Project No.: **16M123-1**

Subject: **Change of Engineer of Record, Response Report and Plan Review**  
Building D  
SEC of Oleander Avenue and Decker Road  
Riverside County, California

2) Review Comments, Riverside County Planning Department, County Geologic Report No. 2491.

UPDATED GEOTECHNICAL MAP  
BUILDING D  
RIVERSIDE COUNTY, CALIFORNIA

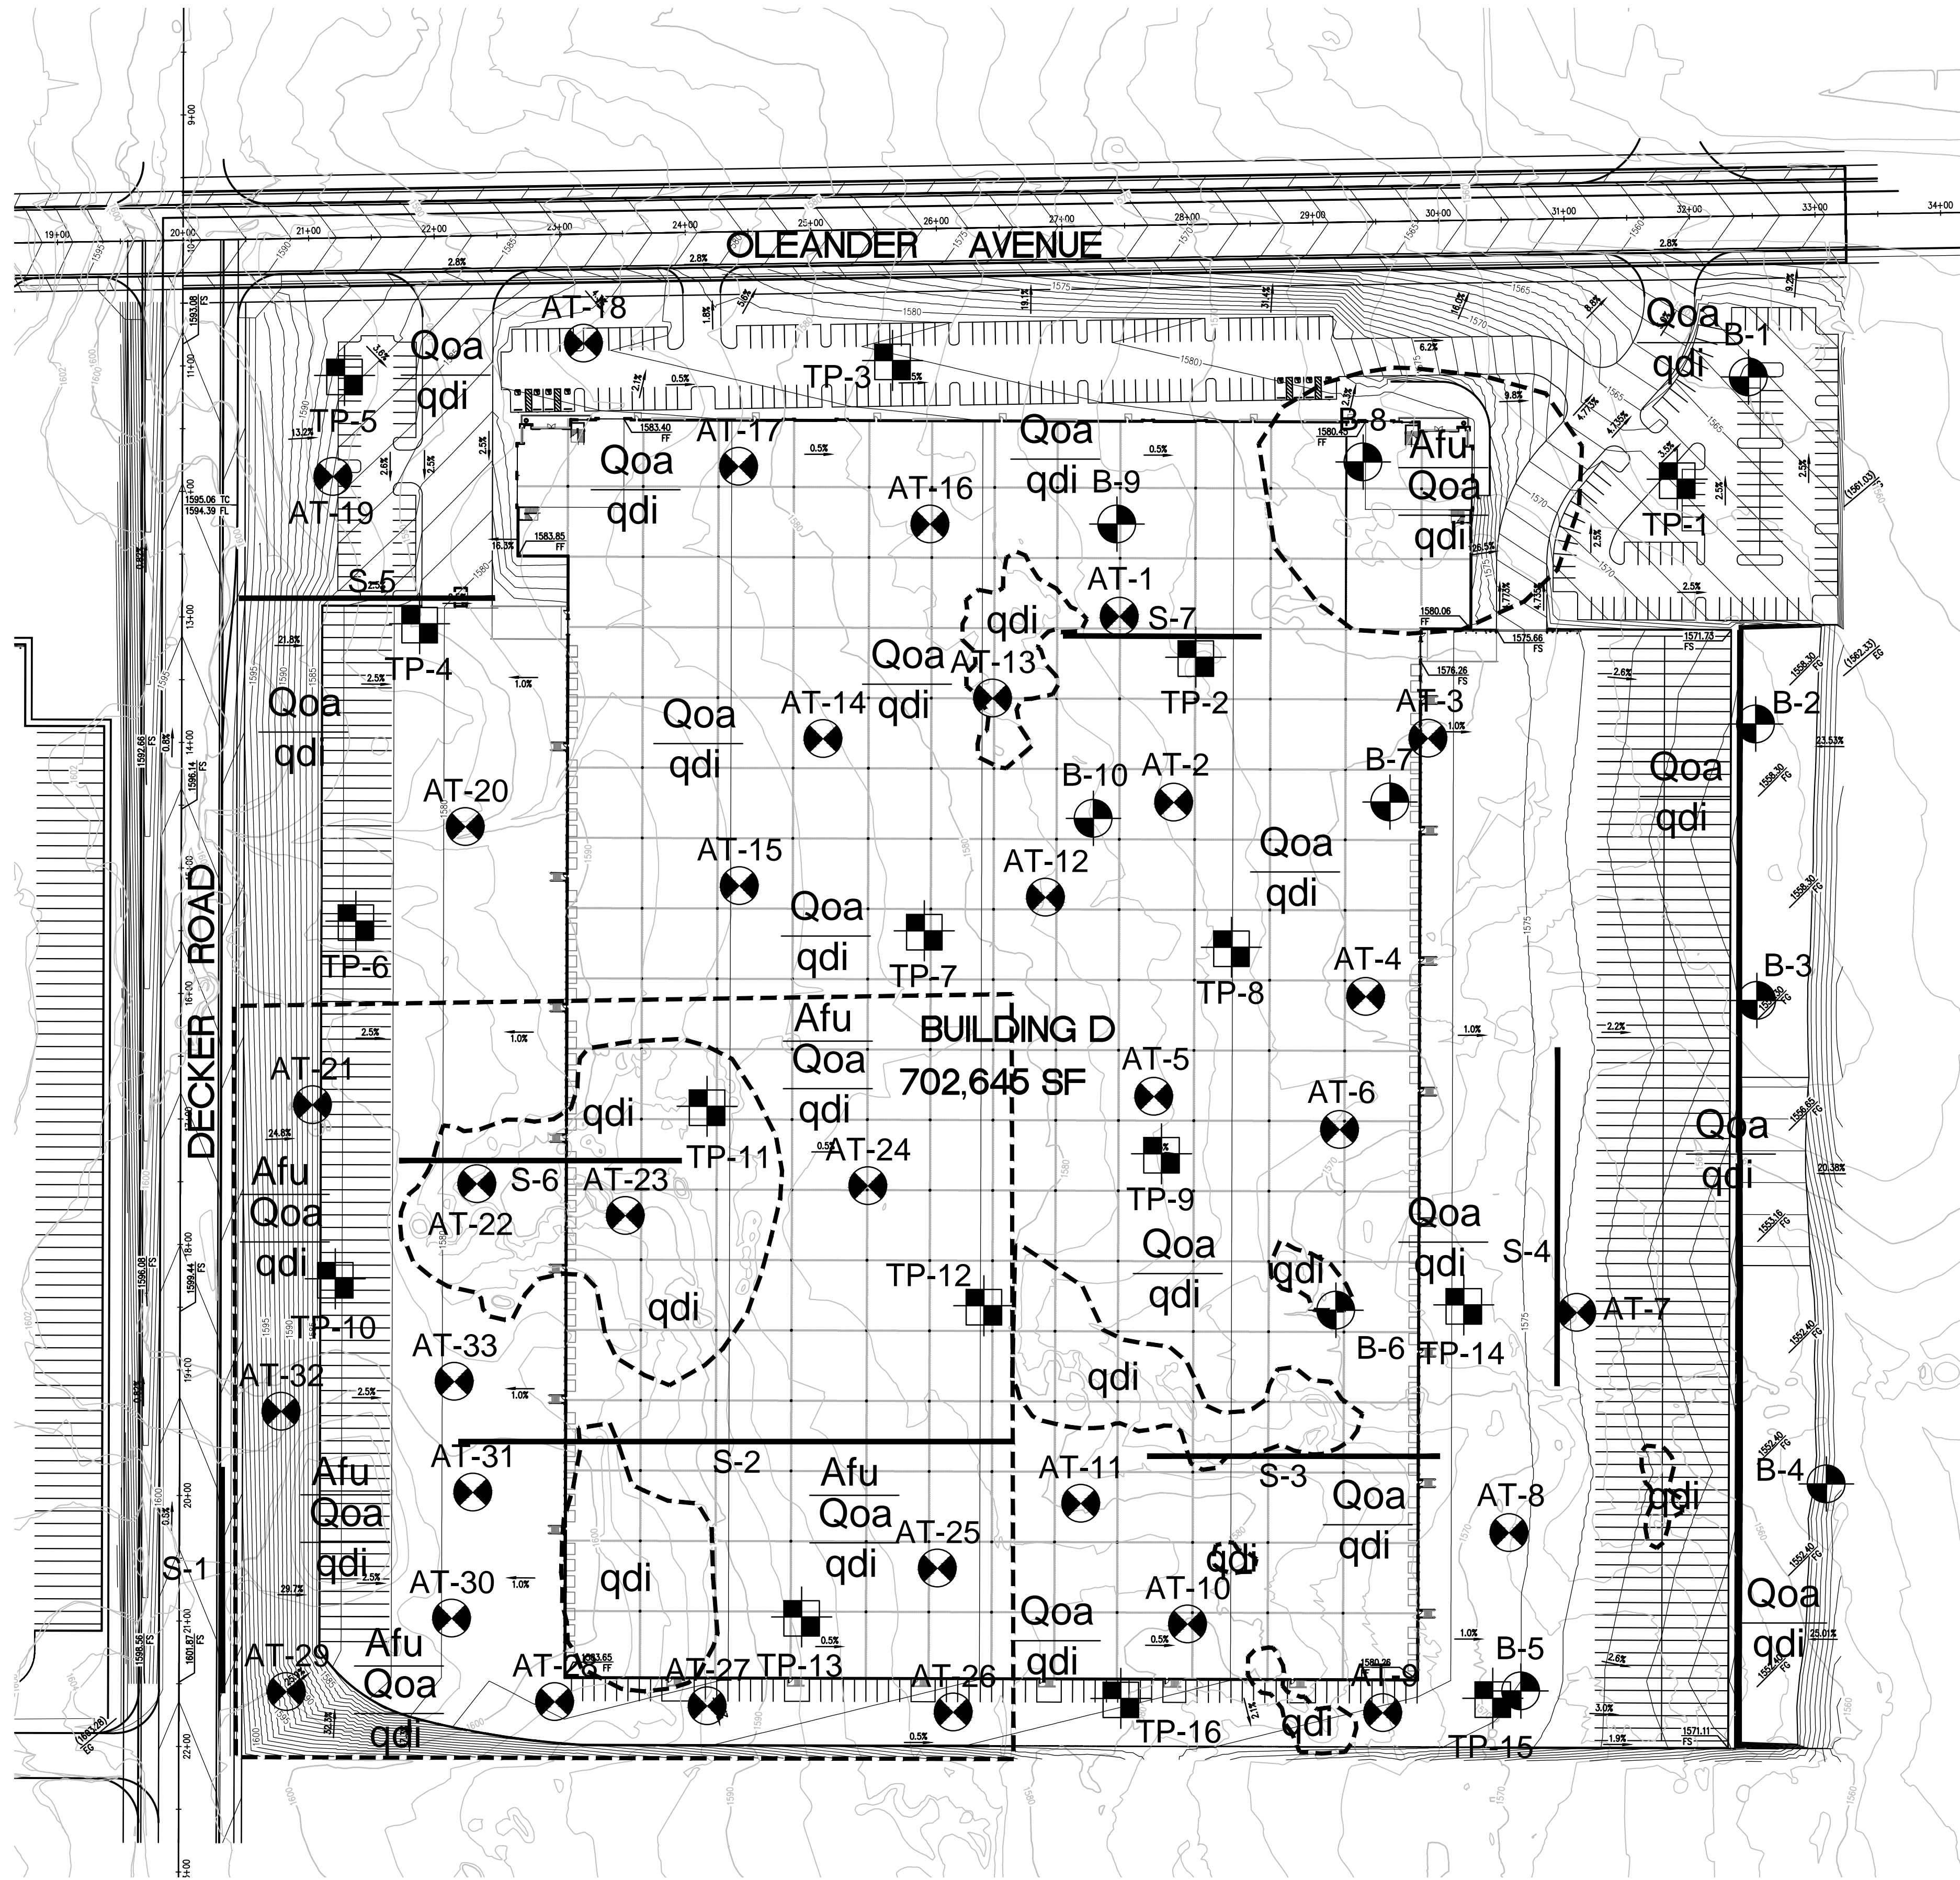
RPD 9: *Please provide a north arrow and base map source for the Geotechnical Map.*

SCG: A north arrow and base map source has been included with the updated Geotechnical Map.

# USGS Design Maps Summary Report

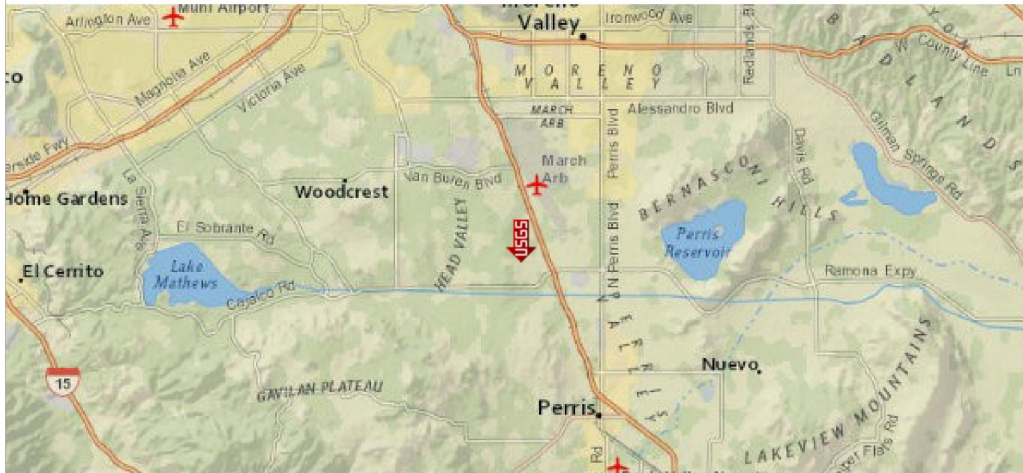
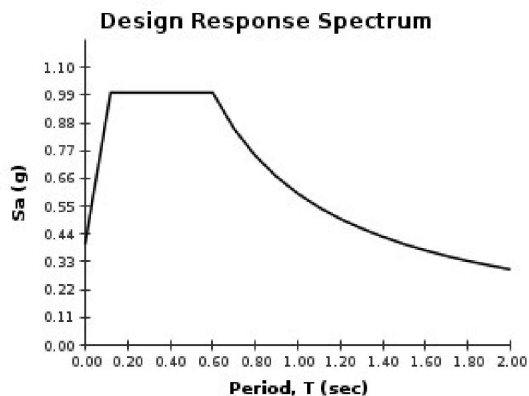
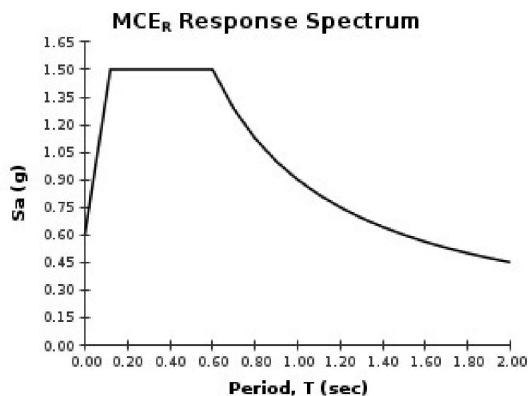
RPD 4: *Please provide a  $PGA_M$  and Seismic Design Category for the site.*

SCG: Seismic parameters and Site Design Category are included in a subsequent section of this report.

The peak ground acceleration ( $PGA_M$ ) for this site was determined in accordance with Section 11.8.3 of ASCE 7-10. The parameter  $PGA_M$  is the maximum considered earthquake geometric mean ( $MCE_G$ ) PGA, multiplied by the appropriate site coefficient from Table 11.8-1 of ASCE 7-10. The web-based software application U.S. Seismic Design Maps (described in the previous section) was used to determine  $PGA_M$ , using ASCE 7-10 as the building code reference document. A portion of the program output is included as Plate E-2 in Appendix E of this report. As indicated on Plate E-2, the  $PGA_M$  for this site is 0.50g.

Plate:    C-1

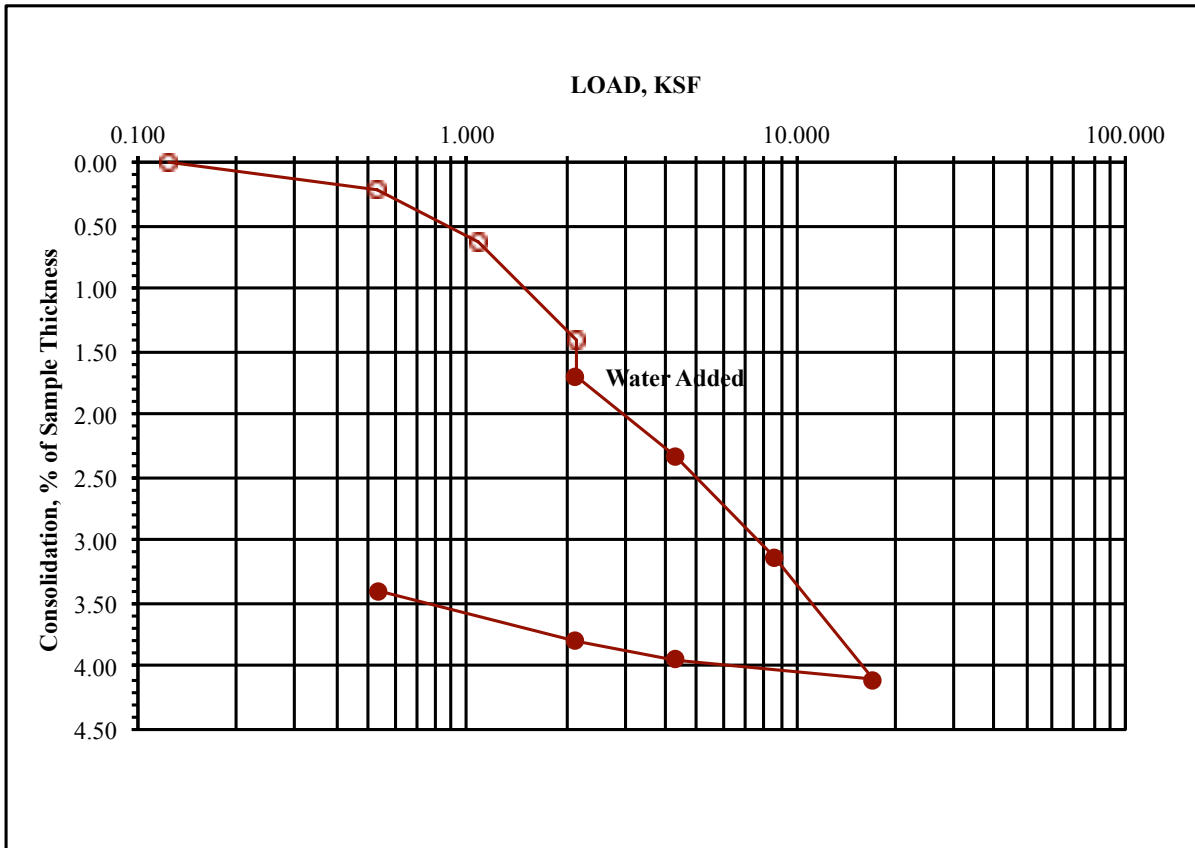
RPD 8: *Appendix C states that consolidation testing was performed and results are presented on Plate C-1, C-2, and C-3; however, these plates are not included in the report copies submitted to the County. Please provide.*

SCG: Plates C-1, C-2, and C-3 for the original MGC geotechnical investigation are included with this report.
